Deputation to Vaughan City Council  
July 13, 2020  
Agenda Item #5  
OP.20.002  
Mizrahi Constantine (180 SAW) Inc.

COMMUNICATION - C94  
CW (PH) - July 13, 2020  
ITEM # 5

**Appendix 1 - Green Space Shortages**

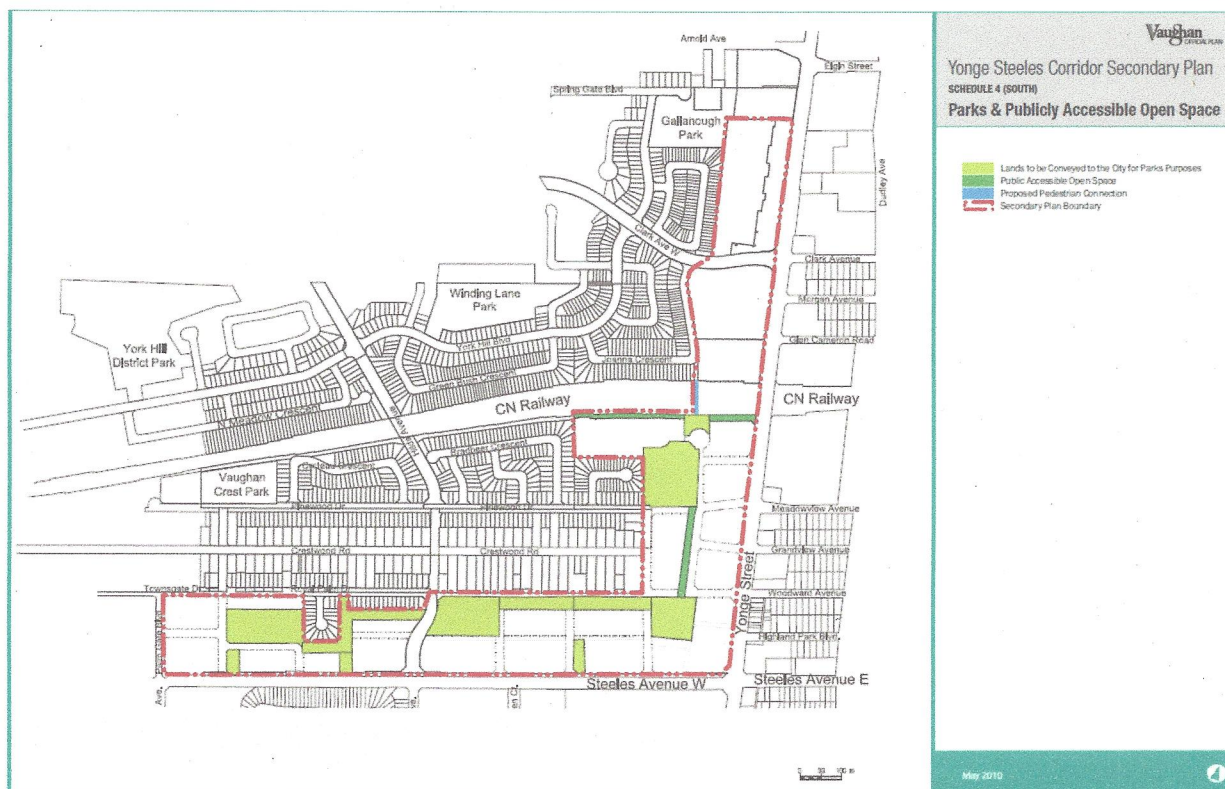
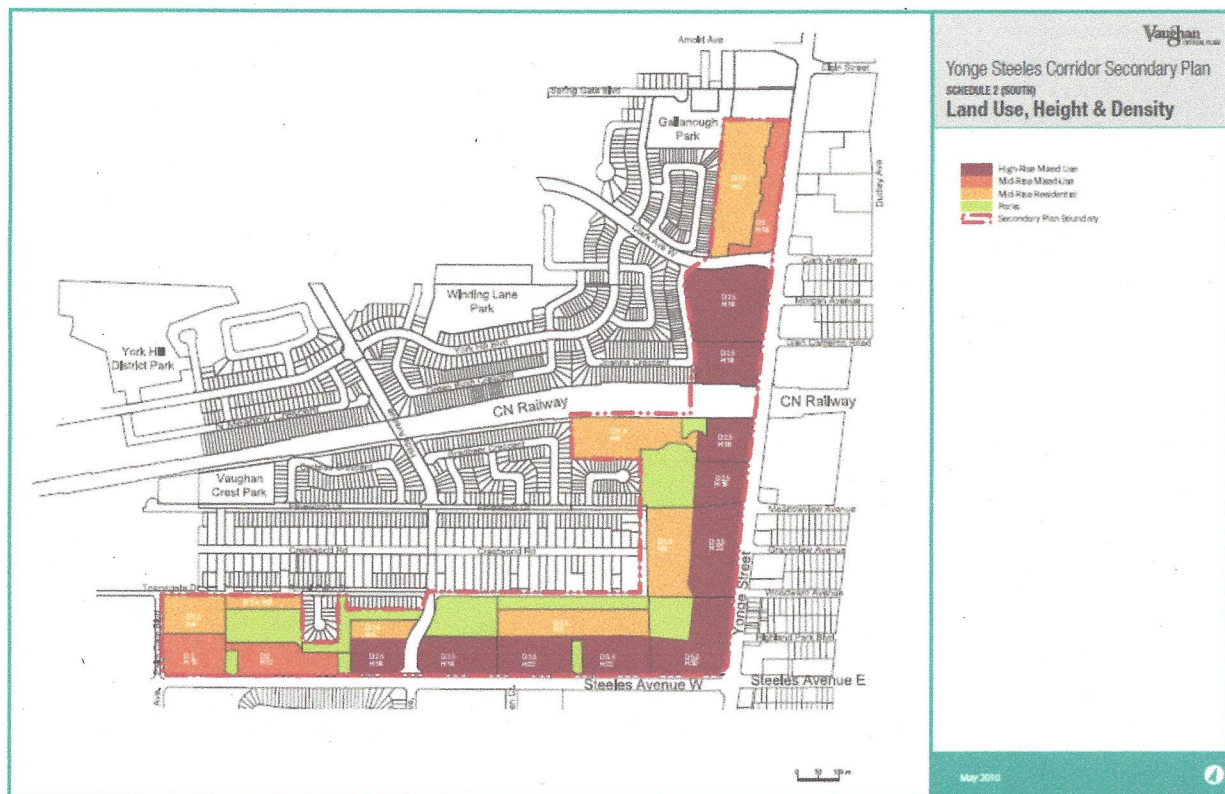
As can be seen in Schedules 2 and 4 below (marked in green), the Secondary Plan incorporated a significant portion of land in the area to serve as a green "buffer" and connector transition

between low-rise residential and the mid-rise residential properties. In particular, we note the designation of a linear park of roughly a 50-foot width on the southern side of the Royal Palm Drive Extension from Hilda to the southern extension of Powell Road.

**Figure 1: Mizrahi Detailed Site Landscaping (Urban Design and Sustainability Brief, p.87)**

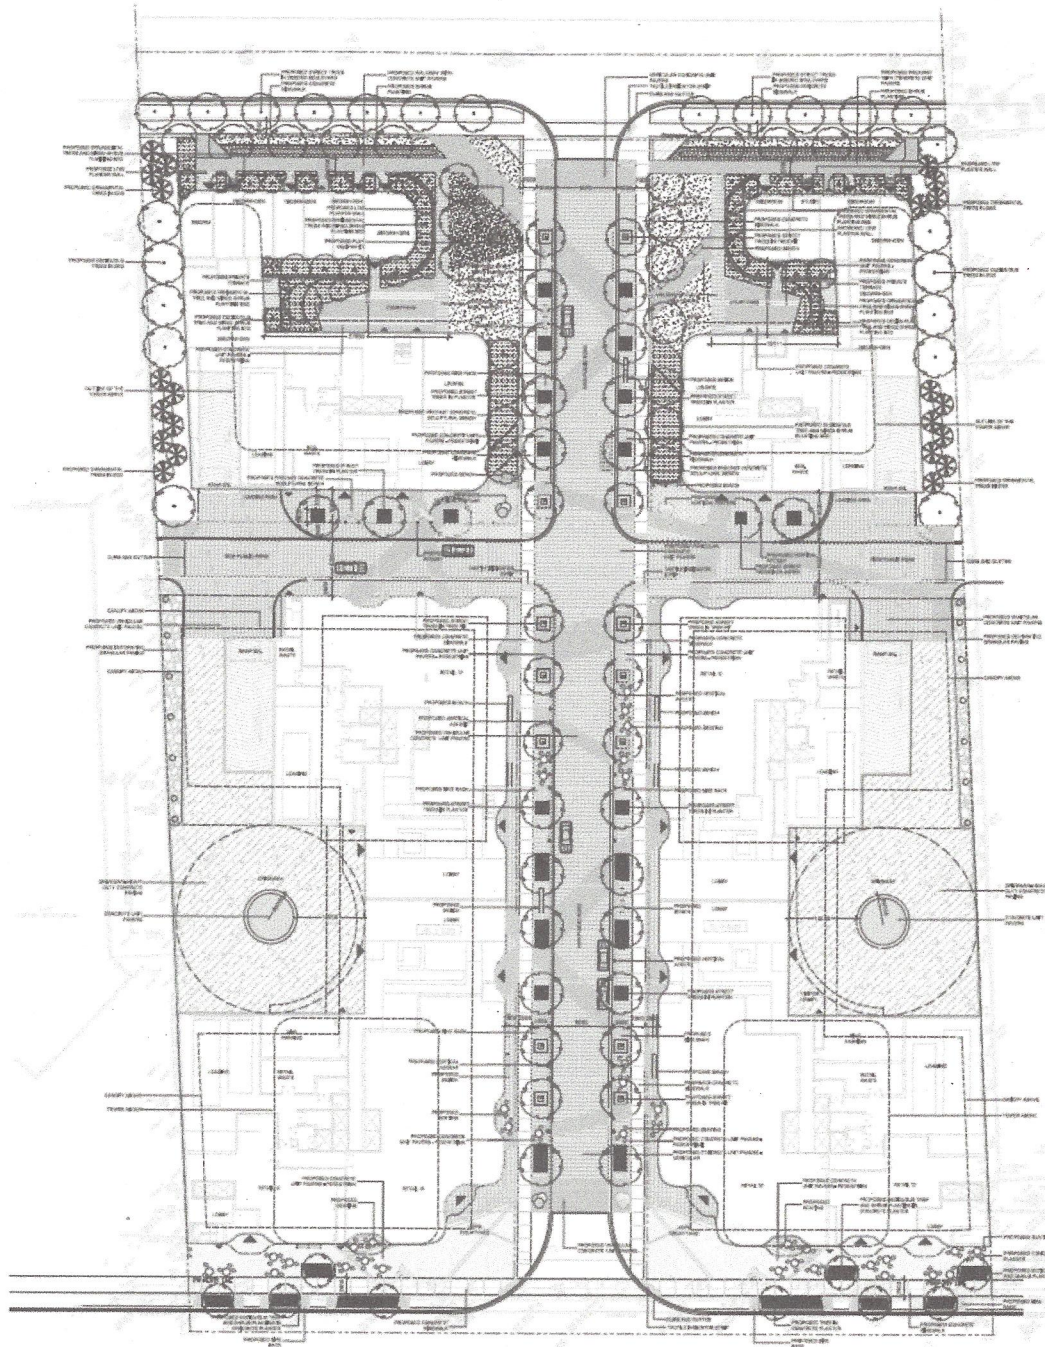
It is therefore both surprising and glaring that the Mizrahi (Figure 1) proposal includes only a small strip of trees (two and one row, respectively) on the south side of Royal Palm for any green space, despite the very deep lot of 180 Steeles Ave West. They have instead provided podium rooftop “amenities” for the exclusive use of the building residences, but inaccessible and therefore prohibited to nearby established residences.

Mizrahi has not provided any land for public park, and any green or open space amenities and landscaping (aside from a small row of trees on the north end of the property) are all contained within and for the exclusive benefit of the new buildings. These omissions were frequently identified in the May 28, 2020 Design Review Panels for this project.

This omission of a linear park system is a missed opportunity for a significant green “ribbon” with potential amenities such as bike paths, water fountains/splash pads, sculptures, benches, playgrounds, gazebos, etc. We urge Mizrahi to reconsider their plans and design for a vibrant and substantial green ribbon linear park as envisioned and required by the Yonge-Steeles Corridor Secondary Plan.
